APPLICATION FOR ZONING CHANGE

Date 2-25-91NAME OF PROPOSED DEVELOPMENT Steger Retail AdditionLOCATION OF PROPOSED DEVELOPMENT N.E. corner of FM 740 and
FM 3097NAME OF PROPERTY OWNER/DEVELOPER Estate of O.L. Steger, Jr. and Emily Sue
Whitehead
c/o Lakeside National BankADDRESS P.O. Box 9PHONE (214) 771-8311Rockwall, Texas 75087NAME OF LAND PLANNER/ENGINEER Winkelmann & Associates, Inc.ADDRESS 12800 Hillcrest Road, Suite 200PHONE (214) 490-7090Dallas, Texas 75230TOTAL ACREAGE 4±CURRENT ZONING ANUMBER OF LOTS/UNITS 1PROPOSED USE FOR DEVELOPMENT Grocery Store

FOOD LION, INC. SITE #50a
F.M. 740 @ F.M. 3097
Rockwall County
Rockwall, Texas

A

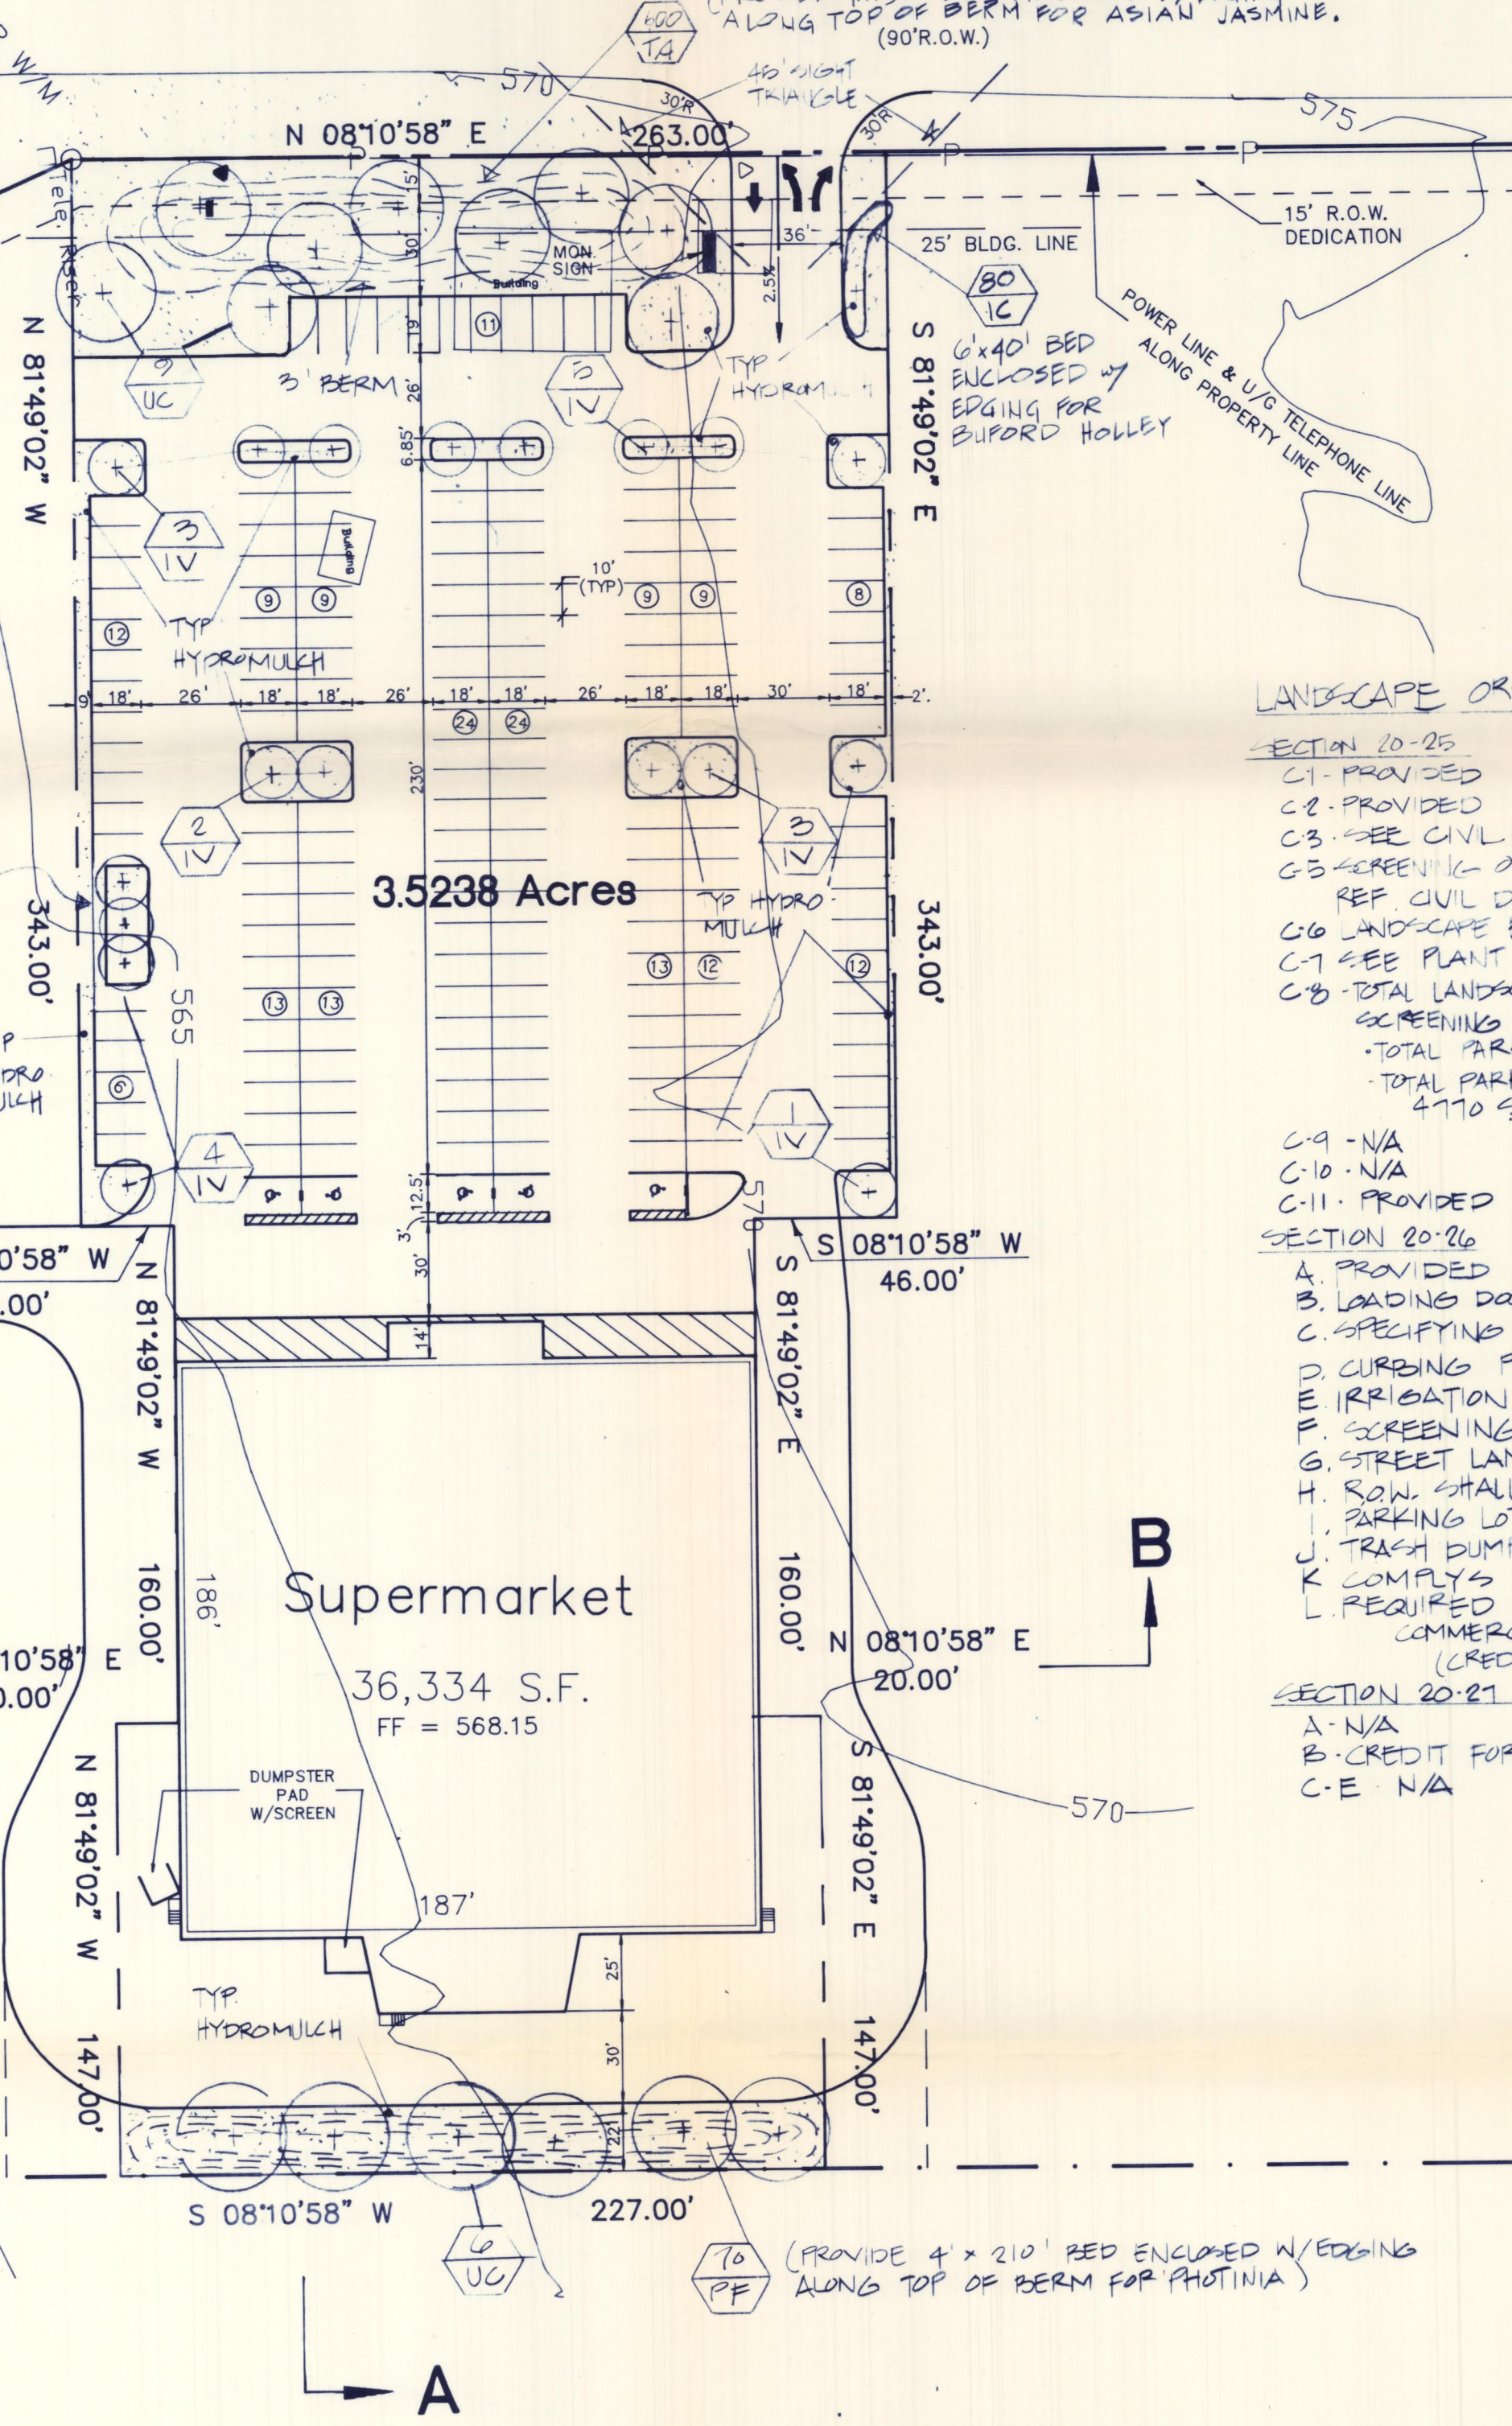
Landscaping Plan

1. The total site requirement for landscaping is 18,708 sq. ft. In reviewing the plan I find approximately 16,600 sq. ft. Please identify the area of the individual landscaped areas. The area to be dedicated as ROW for FM-740 cannot be included in the calculation. I would recommend that you consider including an 8 foot strip between the two center parking stalls. This would provide the additional landscaping area and would enhance the parking lot.
2. You have reduced the percentage of required landscaping by including a 3 ft. berm in the front of the tract. Please identify what landscaping will be planted on

the berm in addition to the required street trees. I would encourage some low maintenance ground cover or low shrubs along the top of the berm. You will need to add 3 foot evergreen shrubs in front of the parking lot on either side of each entrance to fully gain this credit.

4. You need to add 2 more trees along the frontage. In the Overlay District the ratio is one tree per each 30 feet of frontage.
5. You are showing 17 yaupon holly trees internal to the parking lot. These are classified as small trees under our landscaping ordinance. The ordinance provides that one large tree per every 20 parking spaces be provided. This may be considered an equivalent exchange by the Commission, which will be discussion at the meeting.

LANDSCAPE PLAN

1. Winkelmann & Associates, Inc.'s calculations indicate a total of 17,642 square feet of landscape area on the plan as originally submitted. We have eliminated an unnecessary drive to "pick up" 600 S.F. and modified a radius to lose on parking space to "pick up" 180 S.F. and narrowed one drive to "pick up" 360 s.f to provide a total of 18,782 S.F.
- 2 & 4. Modifications have been made in accordance with comments.
5. Information only.
